Subject: Re: Third Site DNAPL Area Call 312-667-5632, code 561227694#

Thank you for your letters dated January 15 and January 19, 2021, requesting informal dispute resolution prior to possible initiation of formal dispute resolution under the Third Site AOC. EPA is happy to schedule a call at the Trustees' convenience to discuss the issues you have raised concerning EPA's comment on the Supplemental Sampling Report. To help focus that discussion, EPA is providing further clarification and context.

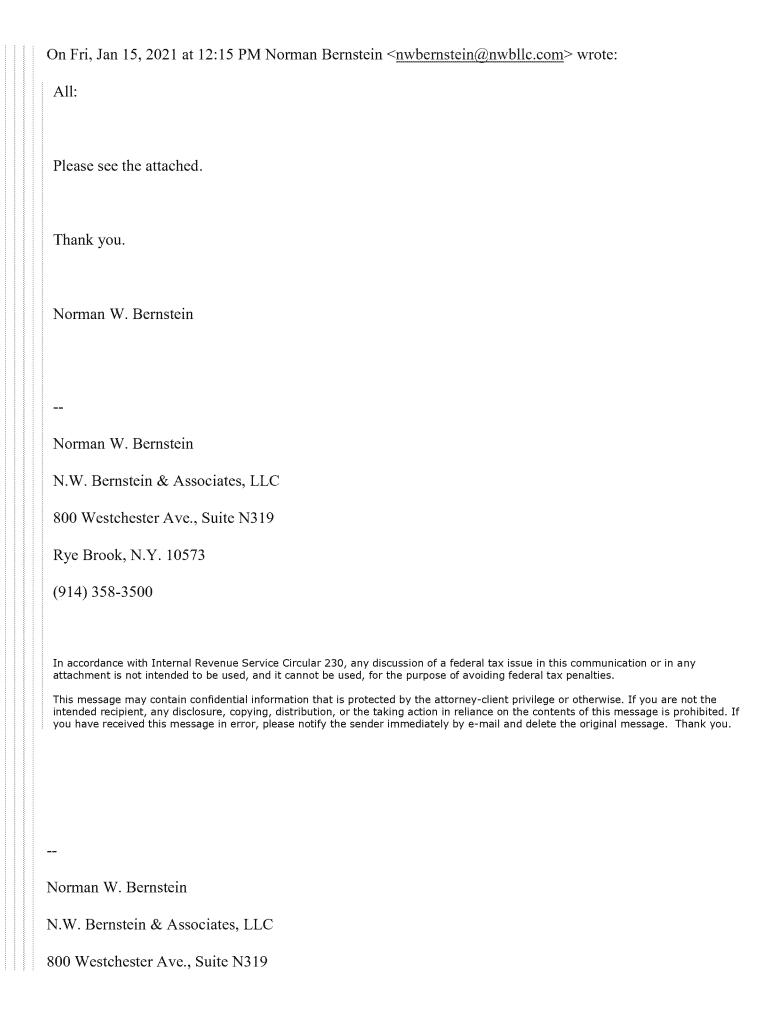
EPA does not object to the Report stating (as it does on page 1), that the supplemental sampling effort was not *specifically* intended to be used for ERH compliance monitoring. EPA's comment that gives rise to this dispute simply asked the Trustees to remove a note that was included in three of the Report's figures. The language of that note -- quoted below -- is unnecessary, and needlessly self-serving and overreaching. It adds nothing of value to the figures:

"For EPA's convenience only, and not as a compliance matter, values in excess of those values at other locations are *Italicized*."

The data that the Trustees gathered from other locations to evaluate ERH's effects is more than just "convenient" – it is intended to be useful and informative. Attempting to minimize or constrain the value of relevant data is confusing, if not disingenuous. Further distinguishing results by use of italic instead of bold

fonts based on which sampling locations produced them seems unnecessary, because *all* of those results are relevant to the stated purpose of the investigation.

The Trustees then seem to transpose EPA's request to keep the information in the figure simple and straightforward into a demand for multiple new compliance points. EPA was simply emphasizing that multiple data points can help the parties assure the accuracy and sustainability of previous measurements and thus the validity of any conclusion that the objective of 90% reduction of total VOCs throughout the DNAPL area has been reached and will be maintained.

The objective of the sampling at the sump and piezometers is to guide treatment for the enclosed DNAPL area. To the extent other valid data become available for other areas of the DNAPL area it would be unreasonable to ignore it, especially when the data were specifically developed to evaluate the treatment's effectiveness. Additional data points may be very useful to confirm that results are generally consistent throughout the DNAPL area (as hoped and expected). They may also identify potential problem areas that may call into question whether cleanup standards have been achieved and will be maintained. This is the very same use of multiple lines of evidence that was a crucial element of the Trustees' own supplemental sampling.

In essence, ERH treatment to break down the contamination throughout the DNAPL area is like cooking a roast. While a roast may not be entirely uniform and so may not cook evenly, after cooking it for a while, the cook inserts a meat thermometer at appropriate representative locations to obtain a good overall indication of whether the entire roast has reached the necessary temperature. It wouldn't be necessary to insert the thermometer at hundreds of locations to confirm the initial temperature readings. But if the cook decides to test several other locations, that additional information can and should inform their judgment on whether the roast is done.

EPA's disputed explanatory language simply states the obvious, given the failure to meet the cleanup standards: "U.S. EPA does not consider treatment to be complete when DNAPL is detected and the total VOC concentration exceeds the performance standard in the DNAPL area." We do not understand why that statement, and the request to remove a specific unnecessary phrase, are objectionable.
